# ARIZONA DEPARTMENT OF ENVIRONMENTAL QUALITY

October 8, 2015  
FPU16-080

RE: WAFB – ADEQ Comments – ADEQ Comments on ST012 SEE Weekly Progress Reports through September 14, 2015

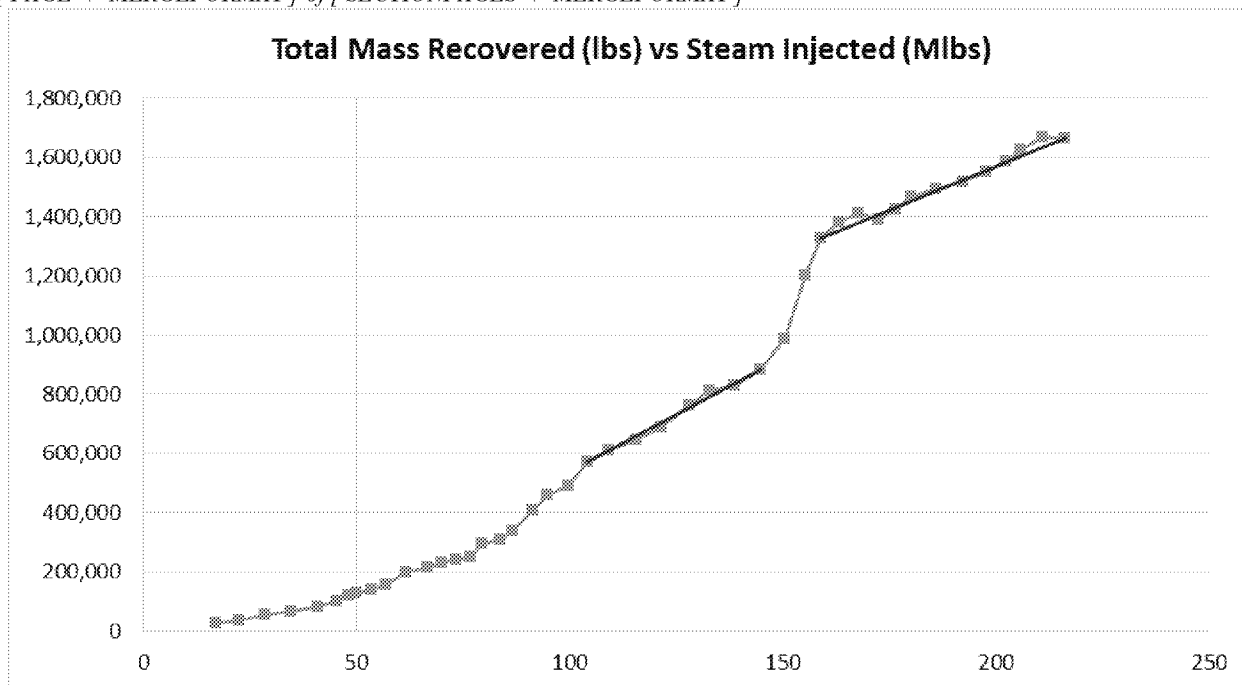
The mass recovery is plotted below as a function of cumulative steam injected instead of date. Steam breakthrough in a number of wells may coincide with the jump in mass recovered between the cumulative steam injection of 150 to 160 Mlbs. However, the rate of mass recovery, illustrated by the slope of the red line, is similar in value before and after the jump in mass recovery. The data do not indicate a significant decay in recovery rate after breakthrough.
